BROWNS FERRY NUCLEAR PLANT (BFN) - UNITS 2 and 3 - TECHNICAL SPECIFICATIONS (TS) CHANGE TS-441 - UPDATE OF PRESSURE-TEMPERATURE (P-T) CURVES

PROPOSED TECHNICAL SPECIFICATIONS (TS) CHANGE TS-441 TVA EVALUATION OF PROPOSED CHANGE

**PROPOSED TECHNICAL SPECIFICATIONS (TS) CHANGE TS-441
MARKED PAGES**

PROPOSED TECHNICAL SPECIFICATIONS (TS) CHANGE TS-441
REVISED PAGES

**Figure 3.4.9-2
Pressure/Temperature Limits for
Reactor In-Service Leak and Hydrostatic Testing**

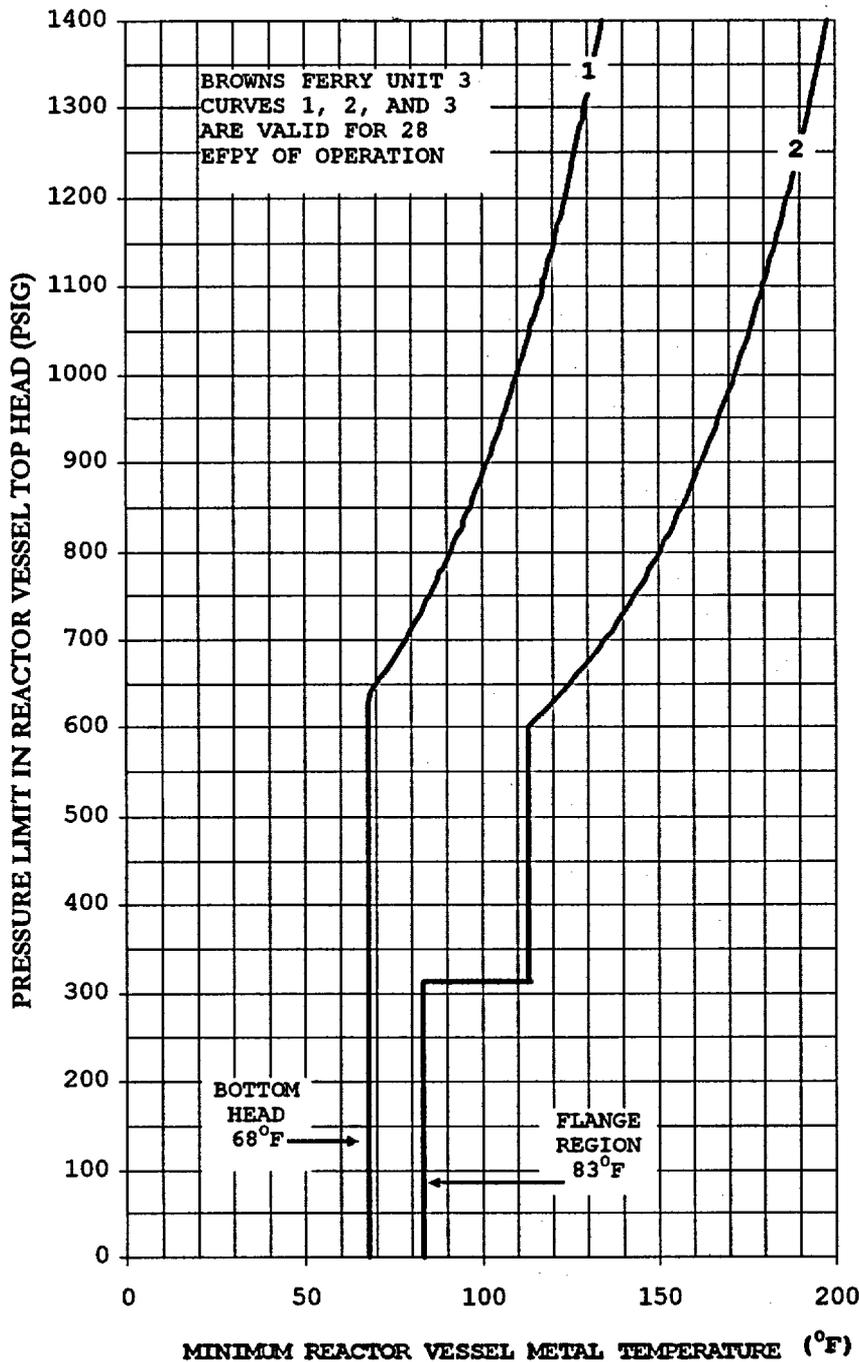
These pages are submitted for NRC review and approval, however, they will not be placed into the BFN TS at this time. As Unit 2 approaches 23 EFPY, and as Unit 3 approaches 20 EFPY, TVA will replace the TS figures shown in Enclosure 3 above with these figures.

Notes
These curves include sufficient margin to provide protection against feedwater nozzle degradation. The curves allow for shifts in RT_{NDT} of the Reactor vessel beltline materials, in accordance with Reg. Guide 1.99, Rev. 2, to compensate for radiation embrittlement for 28 EFPY.
